ADMINISTRATIVE AMENDMENT TO PUD 93 - AMENDMENT NO. 2

THEREFORE, we hereby approve the following administrative modifications to Planned Unit Development (PUD) No. 93:

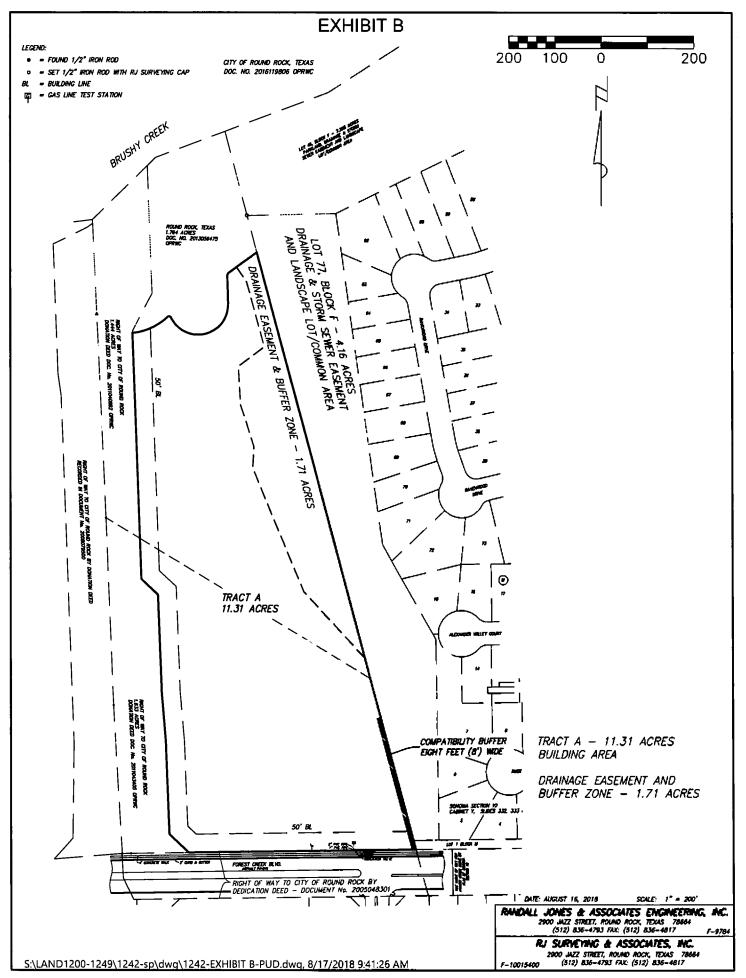
3. Section 8. - Compatibility Buffer is amended to read as follows:

A compatibility buffer, consisting of landscaping and a fence shall be required along approximately 350 feet of the property line, as indicated on Exhibit "B". The compatibility buffer shall meet the following standards:

8.1. Landscaping

- 1) A landscape area of at least eight feet wide shall be provided. The minimum quantity of landscaping within the area shall be:
 - a) One large tree per 50 linear feet with a minimum caliper of three inches, selected from the list of approved evergreen tree species in Appendix B of the Tree Technical Manual;
 and
 - b) One medium tree per 25 linear feet with a minimum caliper of two inches, selected from the list of approved evergreen tree species in Appendix B of the Tree Technical Manual.
- 2) Other than the required landscaping, nothing shall be placed within this landscape buffer, including without limitation, accessory buildings, parking lots, storage of materials and refuse containers. The landscape buffer may not be used as a utility easement.

8.2. Compatibility Fence

A compatibility fence, pre-cast concrete panel or architectural concrete masonry (CMU) with stone accent columns, shall be installed on the property line. The fencing shall closely match the existing fencing along Forest Creek Drive for the Sonoma and Dyer Creek developments, except that the lattice accents shall not be required. The stone accent columns shall be located at a minimum spacing of 100 feet. The fence shall meet the standards contained in Section 8-2 (f) of the Code.
